This response to the Westfield Avenue and Stratford Walk proposals is from **Newham Cyclists**, the local borough group of the London Cycling Campaign (LCC). We represent the interests of people in Newham who already cycle, and campaign for safer streets that would make cycling a mainstream, inclusive, and convenient mode of transport for everyone.

SUMMARY

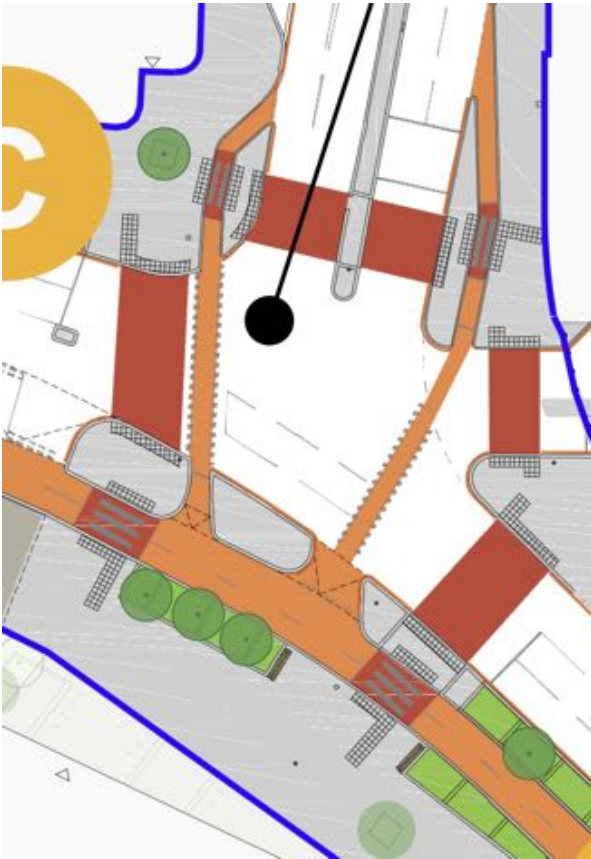
Where	Diagram	Our Comments
<p>Montfichet Road junction</p>		<p>The diagonal crossing and the sharp turn required for people going between Montfichet Road (west) and Westfield Avenue may be awkward for some people, particularly those on larger three-wheelers or recumbents. It is important that the waiting area is large and wide enough to allow people to make the turn, and that the phasing allows people plenty of time to cross.</p> <p>A longer-term way to avoid this, when Montfichet Road west is rebuilt as part of the Pool Street redesign, could be to put the cycle track on the north side of Montfichet Road and have it cross over diagonally at this junction. This would allow those cycling a free turn into and out of Westfield Avenue—likely to be very welcome for those who have just</p>

Where	Diagram	Our Comments
		<p>cycled up the steep incline on Montfichet Road.</p> <p>There may be an opportunity to provide a diagonal pedestrian crossing as well—otherwise people are likely to walk in the cycle crossing.</p> <p>It should be possible to activate the cycle crossing both with a camera and a button to provide reassurance that the traffic light is working and will turn green. This might be an opportunity (with collaboration with DfT) to trial continental-style waiting time indicators, which would be a first for the UK and might encourage more people to wait for a green.</p>
Crossovers	(e.g.)	<p>At these locations the surfacing should be continuous to indicate that people walking and cycling have priority.</p> <p>Sight lines for the crossovers must be kept clear of illegally-parked cars,</p>

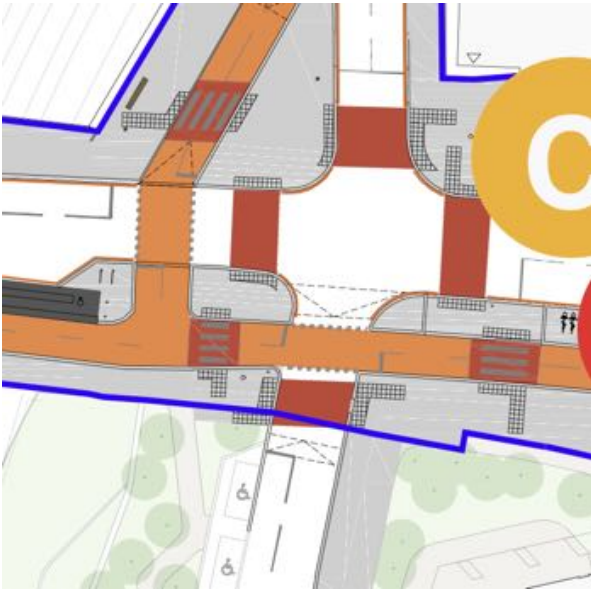
Where	Diagram	Our Comments
		<p>utilities, obstacles etc. to prevent potential 'left hook' collisions.</p> <p>Tactile markings on continuous footways can help cane users navigate by counting side-streets, and allay people's concerns about not knowing where they may encounter cars. These must be carefully positioned (set back) to avoid turning drivers seeing "their" part of the road and bullying people walking and cycling into giving up their priority.</p>
<p>Bus stop bypasses (e.g. at Chestnut Plaza/Endeavour Square)</p>	<p>(e.g.)</p>	<p>The designs here are good examples of bus stop bypasses that match up to best practice standards in the UK and on the continent. Cycle compliance with zebra crossings on BSBs is best</p>

Where	Diagram	Our Comments
		<p>when bus users and cyclists have clear sightlines towards each other, and no-one has to negotiate tight chicanes or obstacles.</p> <p>We are pleased that the cycle track is in a straight line allowing cyclists to focus on watching for pedestrians rather than not hitting a kerb.</p> <p>The siting of the planting areas should nudge bus users into using the zebra crossing. However, if very high volumes of people are forecast to alight here, it may be wise to provide some kind of barrier on the island to prevent people from stepping out into the cycleway without realising it and funnel them to the zebra crossing. This could take the form of a less obtrusive form of guardrail than there is currently, or another strip of planting/SUDS.</p> <p>Bus shelters and advertising structures must not obstruct sight lines for people</p>

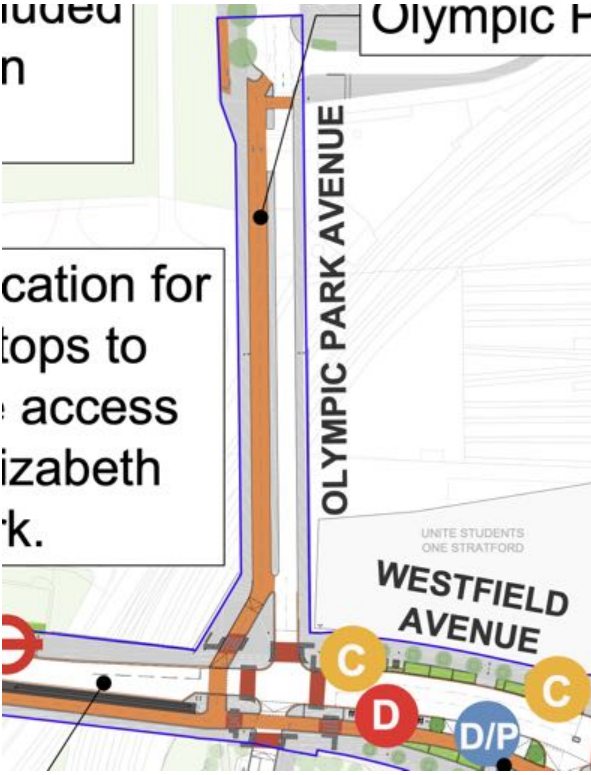
Where	Diagram	Our Comments
		<p>getting on or off buses.</p> <p>Visually impaired bus users may appreciate a change in surface of the cycle track—maybe to a tiled surface—to give an audible indication when cyclists are approaching, in addition to slowing cyclists down. This must be used sparingly, however, or people may choose to cycle in the carriageway instead.</p>
Stratford Walk		<p>The proposed design is a high quality 'destination' area not intended as a through cycle route, but will be attractive to people cycling nonetheless.</p> <p>You may wish to retain some cycle hire stands, or add additional cycle parking, at the Aquatics Centre for people who want to access this location (who may find it more convenient than walking from Westfield Avenue.)</p>

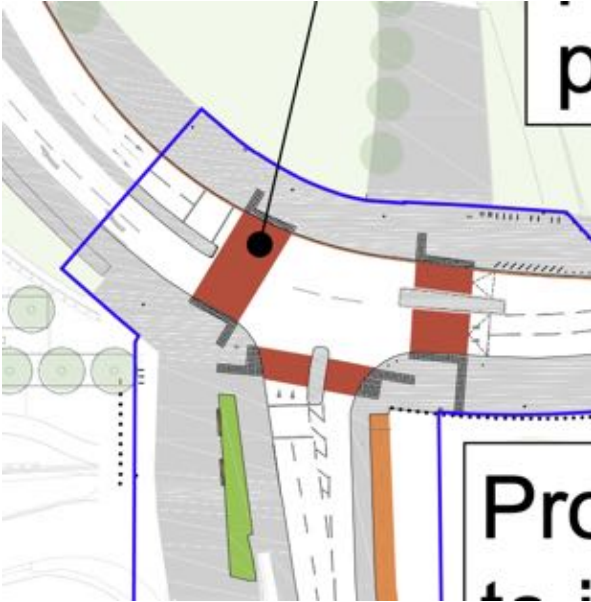
Where	Diagram	Our Comments
International Way junction		<p>Waiting pockets for cyclists turning out of the track are very good. Simplified junction with wide single-stage crossings is good.</p> <p>International Way being for buses and licenced taxis only is good, although we worry that drivers will ignore this (or that it may be seen as a 'release valve' during high-traffic events and opened to general traffic—in fact we believe this may be the case on event days.)</p> <p>The easternmost crossing could do with being 2-way to provide an access route for people cycling to the 'main' Westfield cycle parking in car park C. This could be achievable with a short spur of 2-way cycle track.</p> <p>We would like to see the junction designed with a future extension of Cycleway 26 around the back of Westfield via Celebration Avenue/Stratford</p>

Where	Diagram	Our Comments
		<p>International/Roundhouse Lane in mind.</p> <p>It should be possible to activate the cycle crossing both with a camera and a button—preferably with some indication that the light <i>is</i> going to change to discourage red-light jumping. This might be an opportunity (with collaboration with DfT) to trial continental-style waiting time indicators, which would be a first for the UK.</p>
